ADDENDUM III

**MONUMENT SIGNS AT NORTHEAST LAKEVIEW COLLEGE
KITTY HAWK ROAD, OLD CONVERSE ROAD AND
PALISADES ROAD ENTRANCES**

Bid No. 12C-005

Addendum No. 3

Sheet Number
ADD301-E

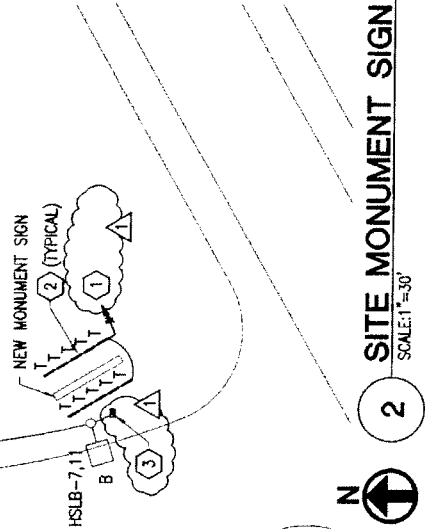
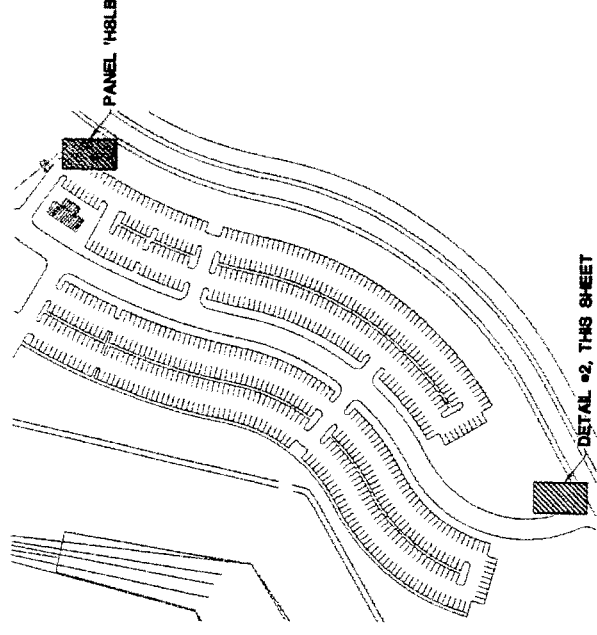
- Item 3.03 Refer to drawing sheet E100 and attached sheet ADD3-01-E:
- Modified Lighting Fixture Schedule.
 - Added transformer at monument sign location.
 - Modified Keyed Notes 1.
 - Added Keyed Notes 3.
- Item 3.04 Reference drawing sheet E101 and attached sheet ADD3-02-E:
- Modified Lighting Fixture Schedule.
 - Added transformer at monument sign location.
 - Modified Keyed Notes 1.
 - Added Keyed Notes 3.
- Item 3.05 Reference drawing sheet E102 and attached sheet ADD3-03-E.
- Modified Lighting Fixture Schedule.
 - Added transformer at monument sign location.
 - Added additional monument sign lights.
 - Modified Keyed Notes 1.
 - Added Keyed Notes 3.

Q1: Circuits for the monument signs are to be 277 Volts as indicated on drawings E100, E101 and E102. However the existing circuits HSLB-7, HSLA-29, HSLA-27 are connected to a 480 Volt, 3-pole circuit breaker.
Do these circuits (HSLB-7, HSLA-29, and HSLA-27) have a neutral wire to obtain 277 Volts as required for the Monument Signs?

A1: Refer to attached drawings ADD-03-1 E, ADD-03-2 E, AND ADD-03-3 E for revisions.

1. CONNECT TO TRANSFORMER SECONDARY WITH 2#10, 1#10GND, IN 3/4".
2. INSTALL TYPE 'T' FIXTURES 4' ON CENTER AND 5' FROM FACE OF MONUMENT SIGN.
3. FURNISH AND INSTALL SQUARE D #151F ENCAPSULATED TRANSFORMER, OR APPROVED EQUAL, AND 30A/2P FUSED HEAVY DUTY DISCONNECT SWITCH TO PROVIDE APPROPRIATE VOLTAGE TO SIGN LIGHTING. EXTEND CIRCUIT AS INDICATED TO TRANSFORMER PRIMARY AND CONNECT DISCONNECT SWITCH AHEAD OF TRANSFORMER. INSTALL TRANSFORMER AND DISCONNECT ON UNSTRUT FRAME.
